## UNITED STATES PATENT AND TRADEMARK OFFICE

<b>Office Action Summary</b>	<b>Application No.</b> 10/539,003	<b>Applicant(s)</b> KRISTENSEN, MICHAEL
	<b>Examiner</b> ELIZABETH VOLZ	<b>Art Unit</b> 3781

**DETAILED ACTION**

**Figure 8 (Hopkins)**

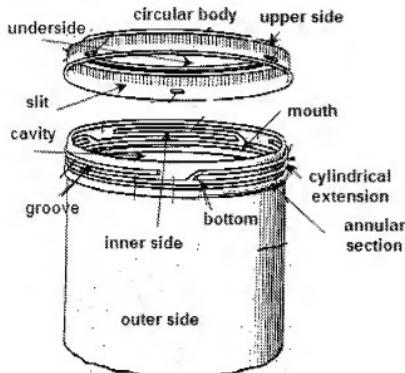
4. Regarding Claim 1, Hopkins discloses a packing with screw thread which includes a container body 64 (Figure 8) with associated lid 70 (Figure 8), a mouth (Figure 8 below) of the container body being constituted by a cylindrical extension (Figure 8 below) with circular cross section, the cylindrical extension having an inner side (Figure 8 below) facing a cavity (Figure 8 below) of the container body and an outer side (Figure 8 below) including an annular section (Figure 8 below) projecting therefrom, including a number of open grooves (Figure 8 below) that are substantially evenly distributed along the outer side circumference, oriented towards a rim 84 (Figure 9) of the mouth and having a bottom (Figure 8 below), where the lid, which is constituted by a generally flat, largely circular body (Figure 8 below) with a diameter greater than a

diameter of the cylindrical extension (Figure 8), with an upper side (Figure 8 below) and an underside (Figure 8 below), interacts with the cylindrical extension for closing the mouth of the packing, as the lid along the periphery includes an annular section 78 (Figure 9) oriented towards the underside of the lid facing the outer side of the cylindrical extension having screw threads 68 (Figure 8) for reception in the grooves by placing the lid on the mouth and by making a relative, turning movement between the lid and the container body, whereby the underside of the lid is pressed against the rim of the cylindrical extension, and where the grooves and the screw threads (Figure 9), respectively, each includes one half of mutually interacting arresting means for arresting the lid in the screwed on position, wherein one half of the arresting means are constituted by a projection 40 (Figure 4) provided in at least one of the grooves close to its bottom and oriented transversely of the grooves and standing up from a bottom (Figure 8 below) of the grooves, and the second half of the arresting means are constituted by the screw threads in the lid having a slit (Figure 8 below) for receiving the projections for detachable arresting of the lid on the mouth in the same moment as the lid assumes the screwed on position on the mouth of the container body with the underside pressed against the rim of the mouth of the container body.

6. Regarding Claim 3, Hopkins discloses an annular projection section 78 (Figure 8) which is conical, as the section closest to an upper side of the lid has a diameter at least corresponding to the internal diameter for the cylindrical extension of the mouth of the container body, and the section closest to the underside of the lid has a diameter being less than the internal diameter of the cylindrical extension, and the sloping side edge runs mainly rectilinearly between the part of the section closest to the underside of the lid and the side running in parallel with the internal side of the mouth of the container body (Figure 9).

7. Regarding Claim 4, Hopkins discloses an annular section 78 (Figure 8) constituting the membrane with the sloping side edge is lowered relatively to the underside of the part of the lid in contact with the container rim in mounted, arrested condition of the lid (Figure 9), whereby the extent of the side of the annular, projecting section pressed with the inner side of the mouth is increased (Figure 9).

**Figure 9 (Hopkins)**

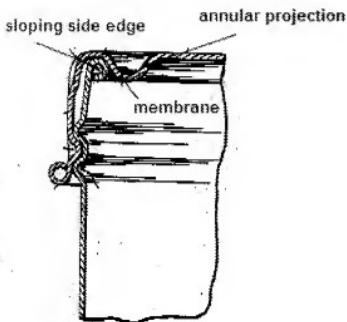
5. Regarding Claim 2, Hopkins discloses a side of the lid facing the cavity of the container body 64 (Figure 8) which includes a membrane (Figure 9 below) centered about a middle of the lid, the membrane constituted by an annular, projecting section (Figure 9 below) which at least includes a sloping side edge (Figure 9 below) oriented towards the mouth (Figure 8 above) of the container body and continuing into a side running in parallel with the internal side of the mouth, the side being pressed against the inner side of the mouth at its rim when mounting the lid in the arrested position, simultaneously with the underside of the lid being pressed against the rim of the mouth of the container body (Figure 9).

Figure 7 (Krueger)

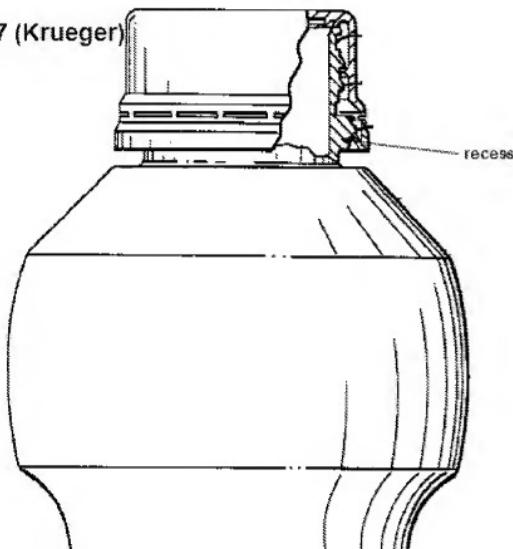
10. Regarding Claim 5, Hopkins discloses all the limitations substantially as claimed except for a section under the open grooves which forms one side limitation of a recess, the other side limitation of which being constituted by a projection at the outer side of the container body, and on the rim of the annular section of the lid there is found a spotwisely fastened, annular ring, to the underside of which with tab hinges are fastened a plurality of downwards projecting and bendable, interspaced tabs along the entire circumference of the ring, the tabs being intended for accommodation in the recess at the outer side of the container body by placing the lid in screwed on position on the mouth of the container body so that the free sides of the tabs are in contact with the side limitation in the recess. However, Krueger teaches a section (Figure 1 below) under the open grooves which forms one side limitation of a recess (Figure 7 below), the other side limitation of which being constituted by a projection 16 (Figure 7) at the outer side of the container body, and on the rim of the annular section of the lid there is found a spotwisely fastened, annular ring 30 (Figure 1), to the underside of which with tab hinges are fastened a plurality of downwards projecting and bendable, interspaced

tabs 34 (Figure 1) along the entire circumference of the ring, the tabs being intended for accommodation in the recess at the outer side of the container body by placing the lid in screwed on position on the mouth of the container body so that the free sides of the tabs are in contact with the side limitation in the recess (Column 3, Lines 38-45).

Therefore, it would have been obvious to one of ordinary skill in the art at the time the invention was made to modify Hopkins to include the above limitations, as taught by Krueger, in order to indicate when the container has been tampered with.

11. Regarding Claim 6, Hopkins discloses all the limitations substantially as claimed except for spotwise fastening of an annular ring to the rim of the annular section of the lid which is made so that the spotwise fastening is broken by a relative turning displacement between the lid and the container body which is oriented opposite to the screwing direction of the lid. However, Krueger teaches the spotwise fastening being broken by a turning displacement between the lid and the container body (Column 3, Lines 45-50). Therefore, it would have been obvious to one of ordinary skill in the art at the time the invention was made to modify Hopkins to include the above limitations, as taught by Krueger, in order to indicate when the container has been tampered with.
